Mark B. Bezilla
Vice President440-280-5382
Fax: 440-280-8029September 9, 2011
L-11-267

Perry Nuclear Power Plant
Docket No. 50-440, License No. NPF-58
Response to Request for Additional Information Related to the 10 CFR 50.55a
Requests In Support of the Third 10-Year Inservice Inspection Interval
(TAC Nos. ME5376, ME5377, ME5379, ME5380, and ME5381)

Response to Request for Additional Information Related to Third 10-Year Inservice
Inspection Interval for Perry Nuclear Power Plant

RHR Pump (Applicable to RHR A, B, and C)

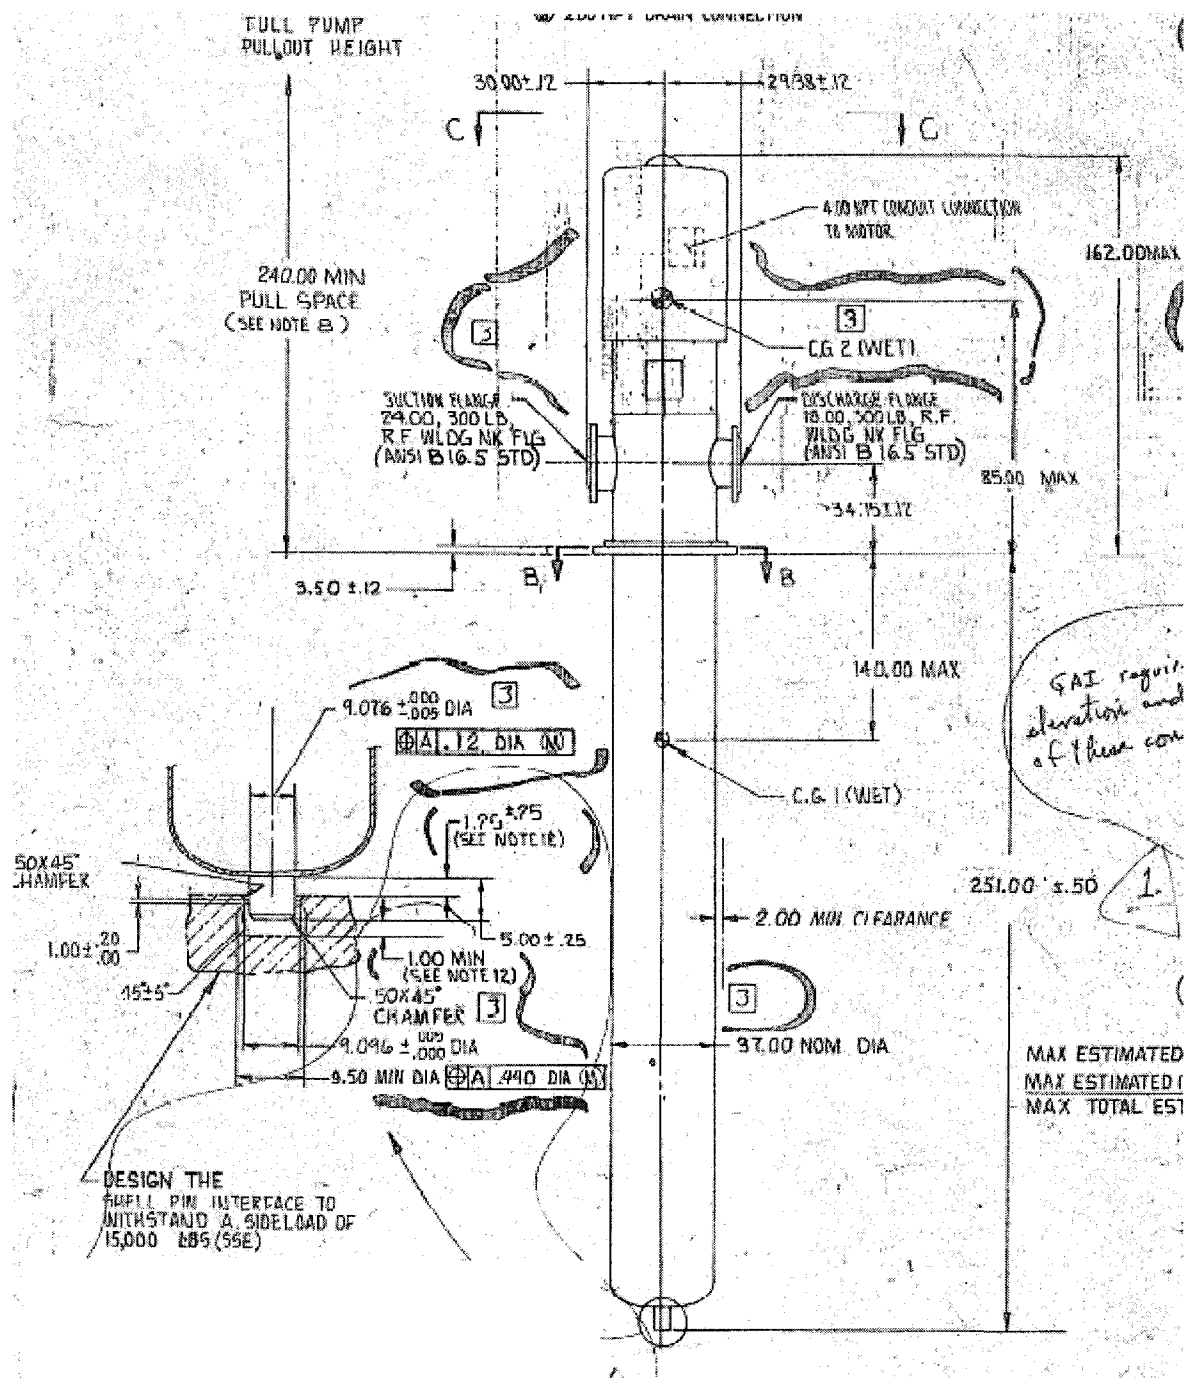
The licensee has provided a typical description and sketch of a pump casing. The description implies that the floor is preventing examinations of all of the casing welds.

- (a) Provide a sketch showing the restrictions. If the restrictions are associated with a pit, provide the approximate depth and annulus dimensions. Show the locations where the pump is in intimate contact with the supporting structure. If the casing below the floor is completely encased in concrete, provide the approximate depth of the encased casing.**
- (b) Provide a discussion on the accessibility for remote visual examinations performed from the outside or inside casing surface (including welds below the floor).**
- (c) Provide a percent estimate of a combined visual and surface examination of the pump casing.**
- (d) Identify the number of pumps in the group being represented by the residual heat removal pump A.**
- (e) Provide a discussion on the effects a crack pump casing weld would have on the functionality of the pump and the effects on the region outside the casing.**

The barrel flange (the sole plate for the pump) is grouted and bolted to the floor and is not designed for routine removal. Thus, the annular space between the pump barrels and the pit walls, which is approximately 4.5 inches for the RHR and LPCS pumps and 2.5 inches for the HPCS pump, is not accessible for surface or remote visual examination. As can be seen in the provided drawings of the pumps, the interior surfaces of the pump barrel welds are only accessible through the suction side of the pump. The only access for remote visual examination from inside the pump barrels is through a 3/4-inch vent connection in the head shell. From there, lowering the fiberscope and locating the barrel welds would be difficult and only those portions of the

circumferential barrel welds directly below the vent connection are able to be inspected. Lowering the fiberscope from the vent connection does not allow for control of the focal distances, making it unlikely that images of sufficient quality could be obtained, even for the very limited areas that could be seen. Based on the above, it is unlikely that any percentage of visual examinations could be credited for distance, lighting, and acuity requirements.

Each of the ECCS pumps has 15 Category C-G, Item C6.10, casing welds of which eight (approximately 53 percent) are accessible. Those on the selected pumps receive the required surface examinations each inspection interval. For the seven casing welds in the barrel below the floor, no examinations are performed.

As indicated in the request, the design and weld configuration for RHR pump A is representative of the five ECCS pumps. With regard to selection for examination, Category C-G Note 1 of the table states that in the case of multiple pumps of similar design, size, function and service in a system, required weld examinations may be limited to all the welds in one pump in the same group. In this context, RHR pump A is only representative of RHR pumps A and B. The design, size and function of RHR pump C is similar, but RHR pump C performs the service of low pressure coolant injection (LPCI) while the RHR pumps A and B perform additional functions; therefore, PNPP groups it separately from the A and B pumps. The functions and service of the LPCS and HPCS pumps are different and also grouped separately. Thus, under Category C-G, four of the five ECCS pumps are selected for examination.
